## Request for approval Surface Reclamation

**RE: Responses to DRMS Cross Shaft Remediation Additional Information Request, in response to GIR Cross Gold Mine, Permit No. M-1977-410, Request for Approval for Cross Shaft Surface Depression Remediation.**

Project: CROSS AND CARIBOU MINE - AM 2 APPLICATION

04

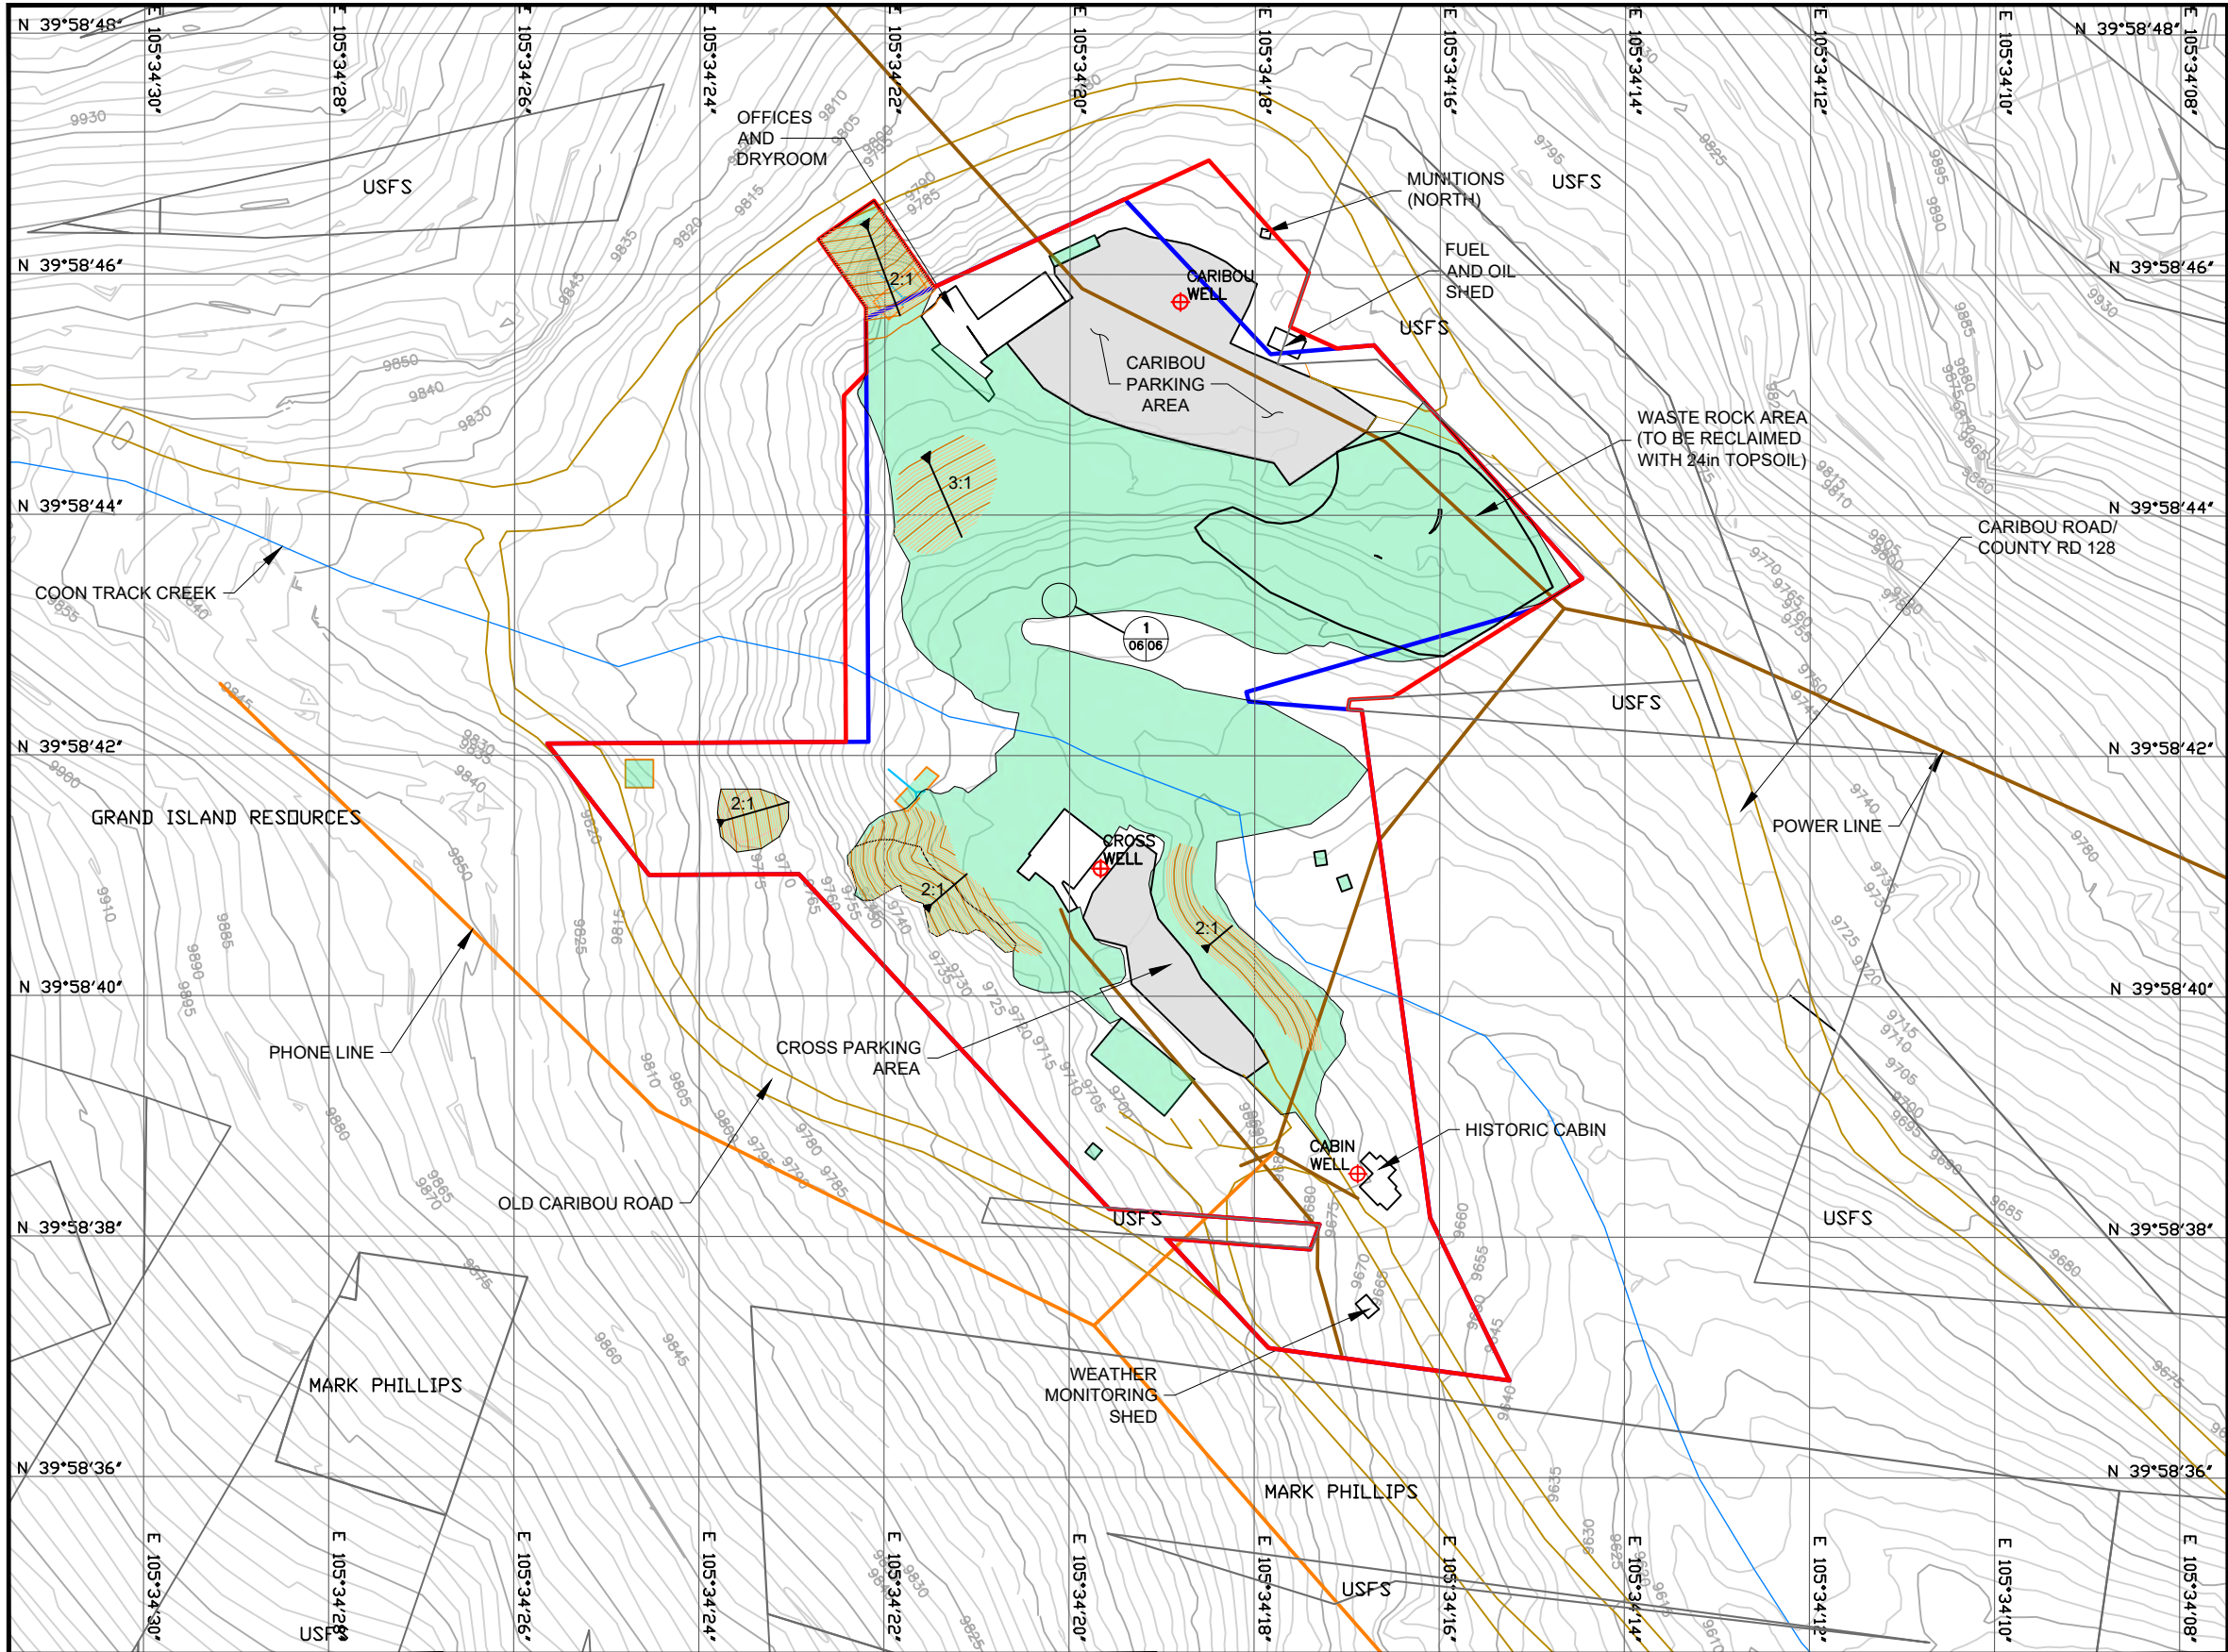
Please provide a location map of the shaft that is to be remediated along with other permit features.

Map 4 from Amendment application #2 (AM-02) depicting the shaft to be remediated along with other permit features is attached.

05

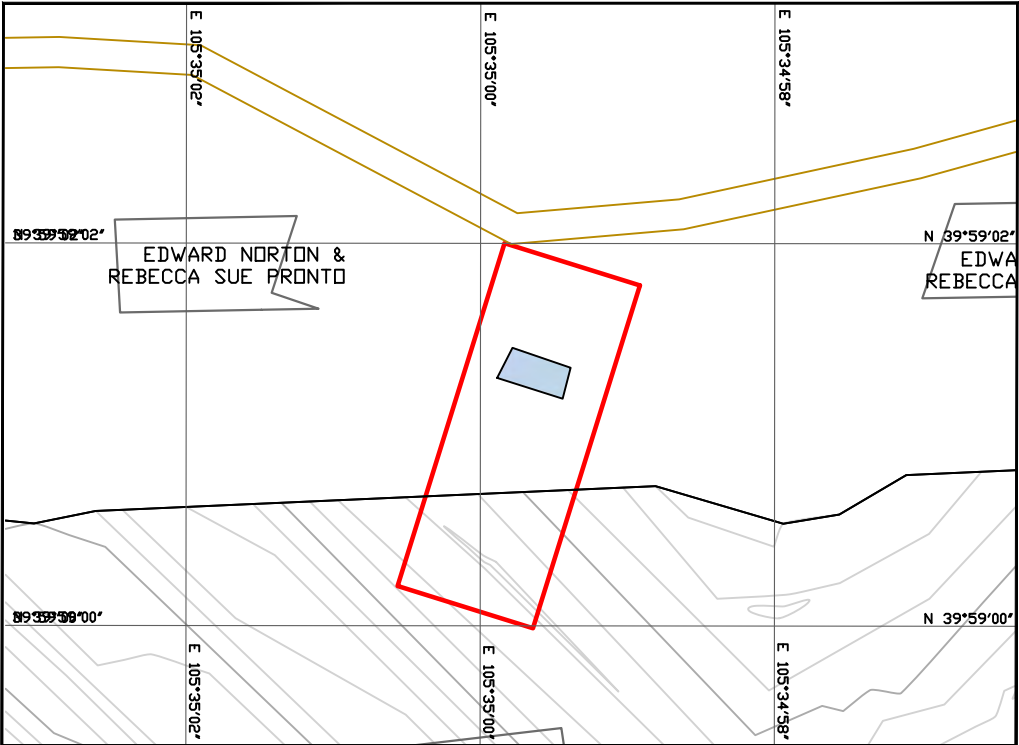
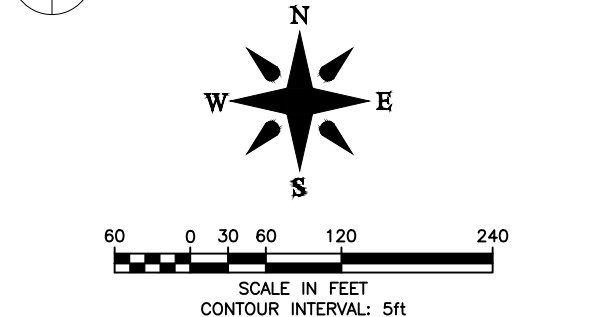
In the operator's May 25, 2021 Response to Preliminary Adequacy Review for Amendment 2, Exhibit D, page 2 the operator states how shafts and adits will be reclaimed, including the Cross Shaft. In Exhibit D it is stated that "All shafts, adits, portals, and ventilation shafts will be closed according to the Colorado Inactive Mine Program standards and specifications (DRMS 2009). Shafts and portals will be plugged with concrete except for the Potosi Shaft, which will be closed with a bat gate (Figure 2). We anticipate that a 40 ft concrete plug will seal the shafts and portals. Shafts and portals will be gated to prevent access. Fences will be 3 feet from the concreted opening and will be 8 feet high with barbed wire. Ventilation and escape way shafts will also utilize either one of the following approved standard methods shown on Figure 3 (DRMS 2009).".

Please clarify the discrepancy between the proposed Cross Shaft remediation and the approved remediation from AM-2.

The Final Revised Version of Amendment application #2 (AM-02), filed by GIR with Division of Reclamation, Mining and Safety (Division), on February 8, 2022, and subsequently approved by the Division on the same date; Section 1.2.6 The Historic Shaft Disturbance, of the approved Amendment, indicates the following: *“The historic shaft disturbance, shown in Exhibit E, maps 5 and 8, will be reclaimed using waste rock. The depression in this area will be regraded to 2:1, re-vegetated using local topsoil, and covered with a sub- alpine seed mix.”*

Maps 5 and 8 from Amendment application #2 (AM-02) are attached.
